# City of Lawrence

LAWRENCE HISTORIC RESOURCES COMMISSION  
AGENDA FOR **JULY 18, 2019**  
CITY HALL, 6 E 6<sup>TH</sup> STREET  
**6:00 PM**

**ITEM NO. 4:** DR-19-00007 (DR-19-00008, DR-19-00325) 901 Missouri Street; Demolition; Certificate of Appropriateness and Oread Design Guidelines. The property is located in the environs of the Johnson Block Historic District, Lawrence Register of Historic Places, and District 1 Low Density of the Oread Neighborhood Design Overlay District. Submitted by Paul Werner Architects for Cherry Hill Properties LLC, the property owner of record.

<b>Lawrence Historic Resources Commission</b>	<b>Item No. 4</b>
901 Missouri Street	<b>DR-19-00007</b>
Demolition	7-18-2019

**PLOT PLAN**  
SCALE: 1" = 10' - 0"

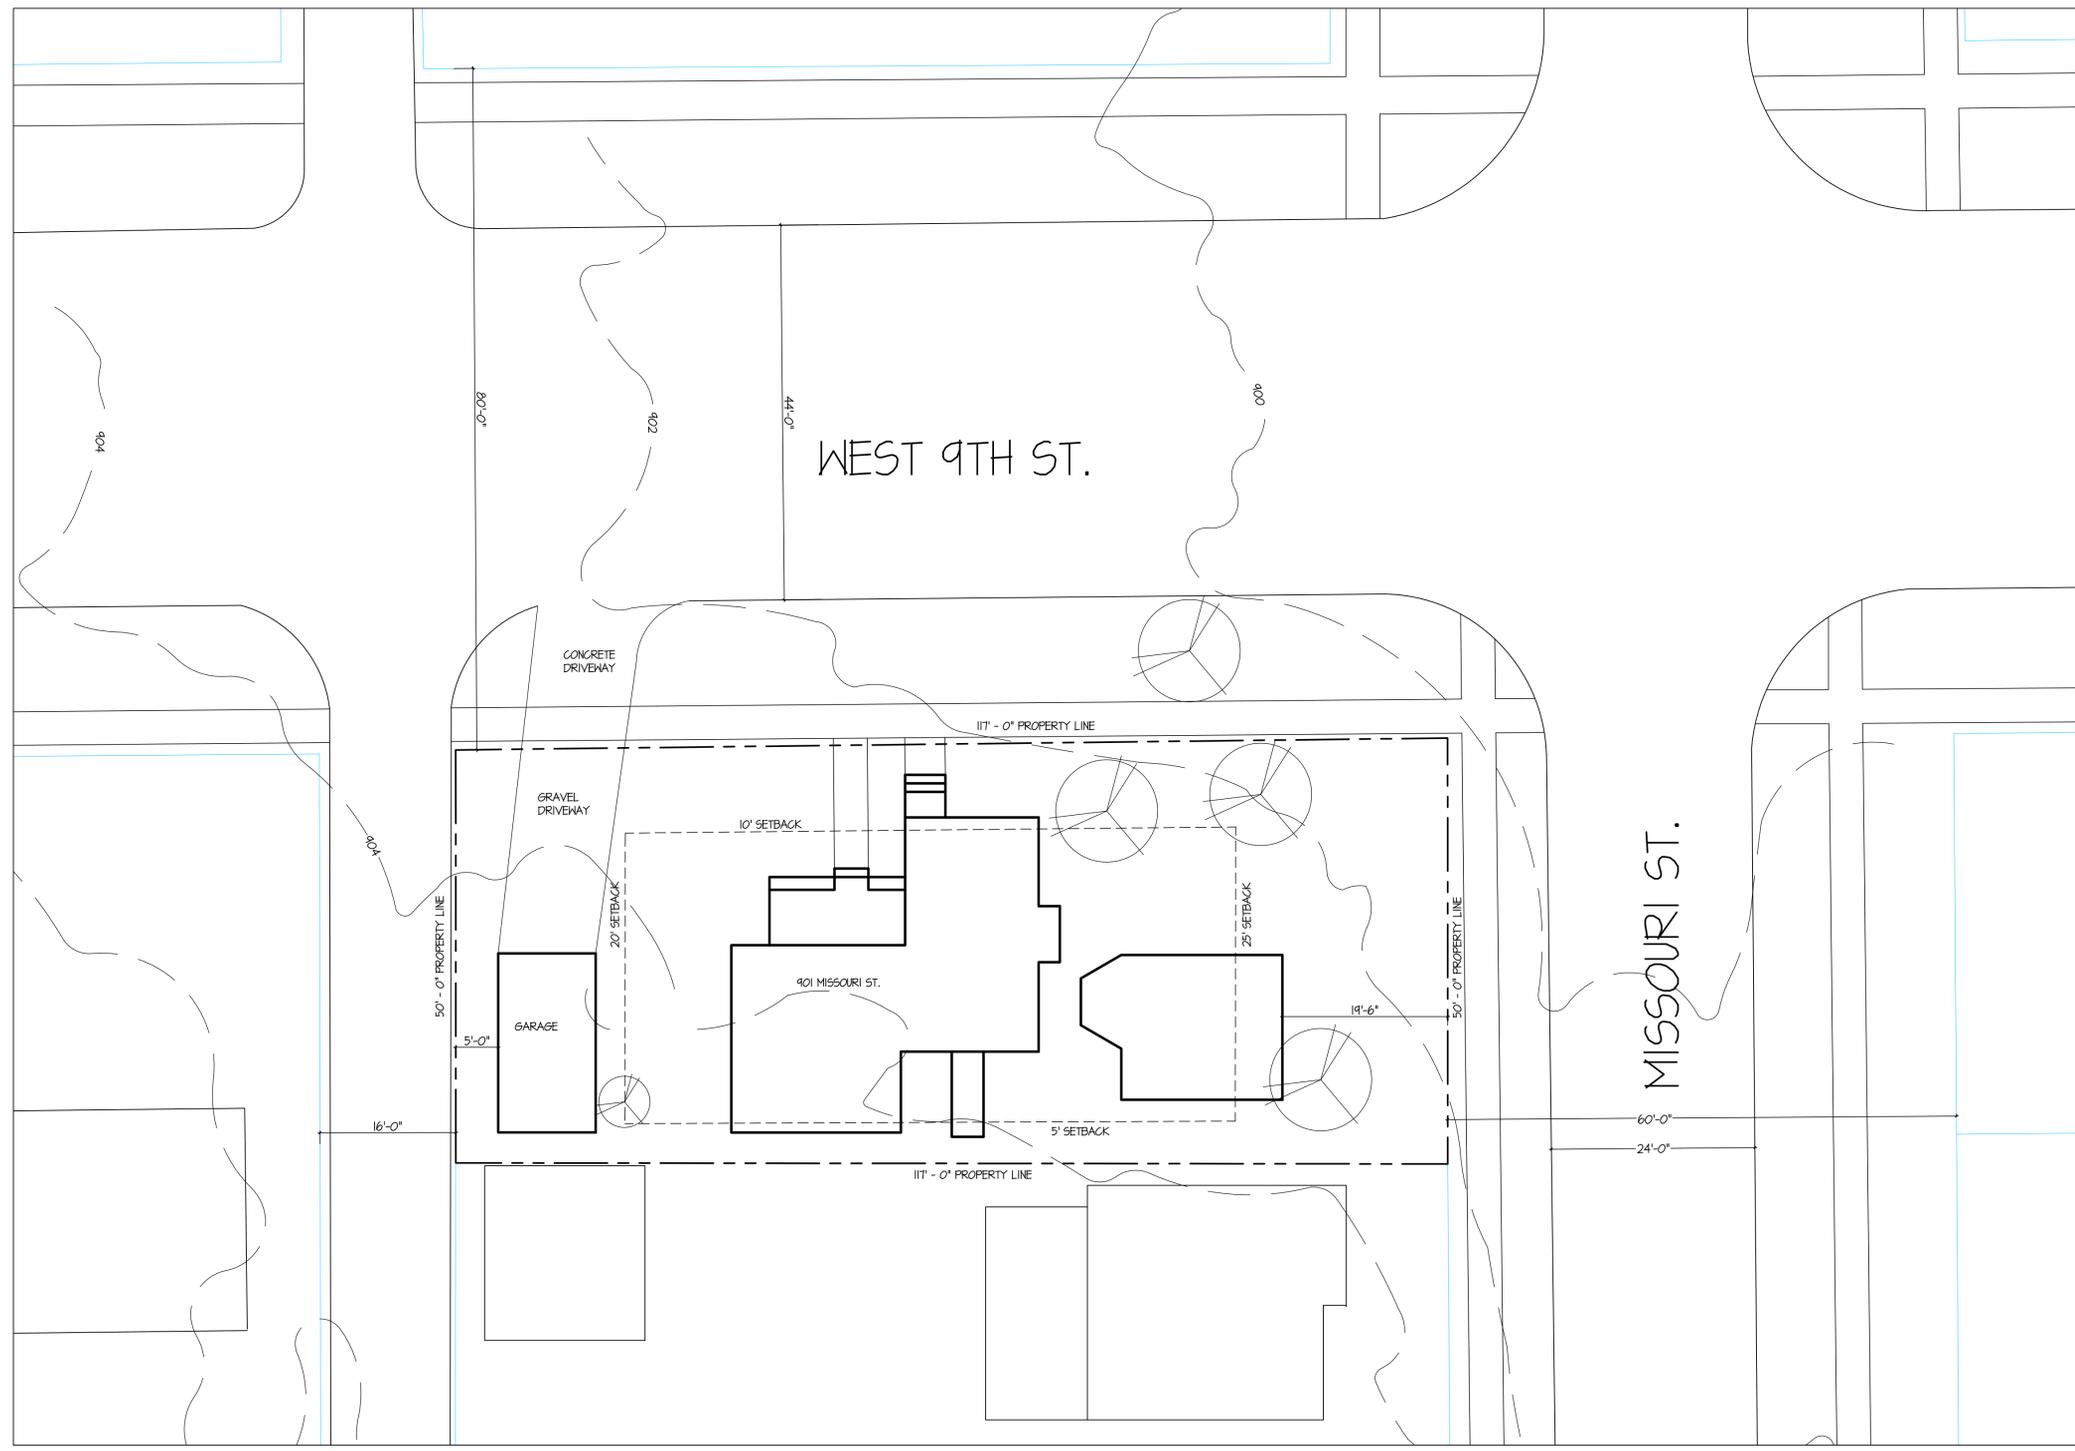
The primary structure located at 901 Missouri Street was constructed c. 1890 according to the Douglas County Appraiser's Office. The second residential structure was constructed c. 1960 according to the Appraiser's Office. The primary structure is currently an "L" form and because of alterations it is difficult to tell which portion of the "L" was constructed as the original portion of the structure or if they were constructed at the same time. Architectural details indicate that the original portion may have been the east/west portion of the structure. The structure is clad with wood lap siding and has an asphalt shingle roof. There are decorative shingles in the gable end of the north/south portion of the structure. There is an exterior brick chimney on the east side of the structure. An altered porch is located in the corner of the "L." The structure is in poor condition.

The current project is a request to demolish all existing structures.

Although the demolition of the primary structure will remove part of the character of the environment of the listed property, the structure is no longer character defining for the environs because of its alterations and condition and the removal of the structure does not encroach upon, damage, or destroy the district.

Staff is of the opinion that the removal of the three structures located at 901 Missouri Street will not encroach upon, damage, or destroy the listed historic district because they are not character-defining because of alterations and deterioration.

Using these criteria, the second residential structure located at 901 Missouri Street is not character-defining and is not subject to guidelines D1 to D6. However, because the structure is over 50 years old, the Historic Resources Commission must use the Secretary of the Interior’s Standards to make a determination on demolition. The Secretary of the Interior’s Standards also uses character-defining features and elements to make evaluations. Because the structure is not character-defining, the standards do not recommend that it be retained.

The primary structure and the garage are more challenging to make character-defining determinations. The condition of the structures and the alterations of the primary structure may cause the structures to be considered non character-defining. Because the structures have been determined to be unsafe and dangerous, the commission may consider this in the evaluation of the contributing status of the structures. The applicant and the Building Code Administrator have submitted information that concludes the buildings should be demolished.

If the buildings are approved to be demolished, a replacement plan should be approved as part of the demolition approval. No replacement plan has been submitted as part of the proposed project. The applicant has indicated that they will submit a project in the future, but they would like to remove the structures now because they are unsafe and dangerous. Any new construction plans shall be submitted for reviewed by the HRC. The new construction will require a Certificate of Appropriateness and review by the Historic Resources Commission. New construction will be reviewed using the design criteria in Section 22-506. These design criteria help to promote the standards set forth in Section 22-505. Specifically, Section 22-506(c)(2) provides review criteria for new construction. Identified criteria for new construction includes but is not limited to building scale, height, orientation, site coverage, spatial separation from other buildings, facade and window patterns, entrance and porch size and general design, materials, textures, color, architectural details, roof forms, emphasis on horizontal or vertical elements, walls, fences, landscaping, and other features deemed appropriate by the Commission. The new construction will also require review using the applicable guidelines in the Oread Neighborhood Design Guidelines.

Staff is of the opinion that the current condition of the primary structure with its alterations renders it non-contributing to the overlay district. While rehabilitation could change the status of the structure to contributing, it is unknown how much original material could actually be salvaged as part of a rehabilitation project. Similarly, the accessory structure could be rehabilitated, but the rehabilitated structure may have the majority of its members new construction.
